Keysford Barn

DESIGN AND ACCESS STATEMENT

Revision C - August 2025

Pre Application | Case Officers Comments

Thermal Upgrades

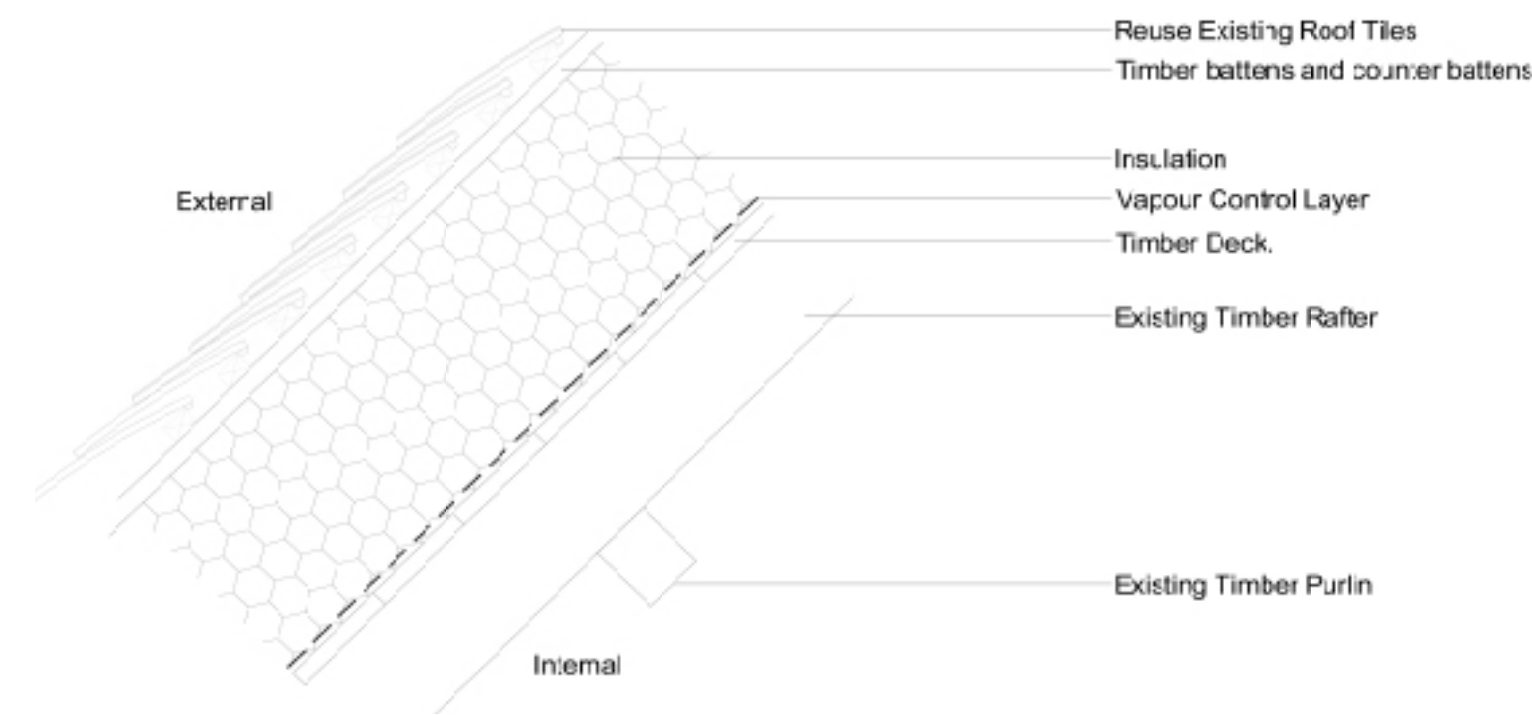
- Any formal application should include typical detail of the manner in which it is proposed to introduce insulation to walls, roof and floor of the building. This should be detailed with a view to retaining fabric and features of interest- for example the timber framing to the walls and roof of the building should remain exposed to view, as this is such a key component of the character of the building. Likewise the introduction of insulation beneath existing historic flooring will require careful consideration. Given the importance of this to the practicality of the scheme and its acceptability in listed building terms I would expect to see this detail as part of an application, rather than by condition.

Noted. We will have provided some ideas as how we would approach the upgrading of the floors, walls and roof and have indicated a thickness of 300mm to the external walls and as well as a raised ridge. With the hope of retaining the exposed timber frame internally.

In order to retain and expose the internal timber frame we must insulate the roof and walls externally. This will involve a deeper wall build up and a raised ridge. See details opposite and the proposed planning drawings for more detail.

Where possible we aim to use breathable insulating materials such as Pavatex and inditherm.

Insulating the floor may prove trickier given the historic nature of the threshing floor. However in order to restore and make this barn usable it is important that we insulate the floor. We are proposing to carefully lift the threshing floor and insert a D3 membrane between the floor structure where the Pavatex insulation can sit and then relay the threshing floor on top.
